**MWO 9-2320-279-20-8**

**MODIFICATION WORK ORDER**

**MODIFICATION OF M983 HEAVY EXPANDED  
MOBILITY TACTICAL TRUCK (HEMTT) TRACTOR**

**INSTALLATION INSTRUCTIONS FOR  
NATO SLAVE CABLE RETENTION DEVICE**

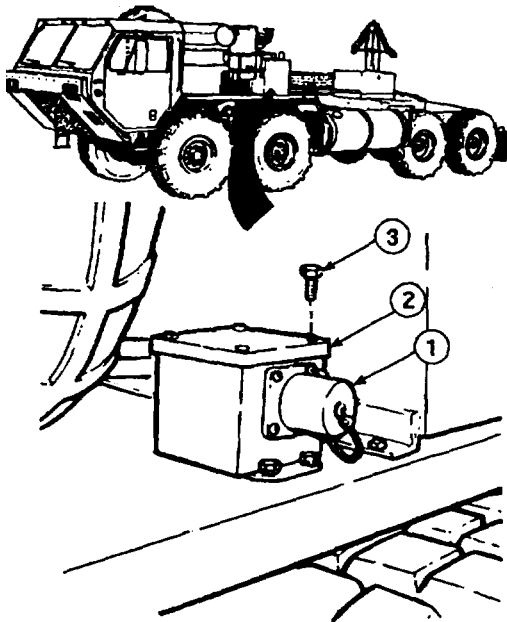
- a. Prepare vehicle for installation of slave cable retention device.

- (1) Remove cap (1) from NATO slave receptacle (2).
- (2) Remove four electrical box screws (3) from NATO slave receptacle (2).

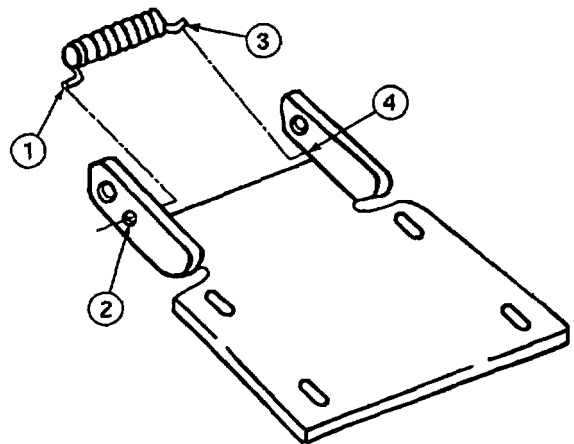
- b. Assembling slave cable retention device.

- (1) Insert spring retainer end (1) into bracket hole (2).
- (2) Place opposite spring retainer end (3) under bracket retaining bolt hole end (4).

- (3) Insert spring retainer end (3) in bracket hole (5) and position bracket (6) in bracket (7).
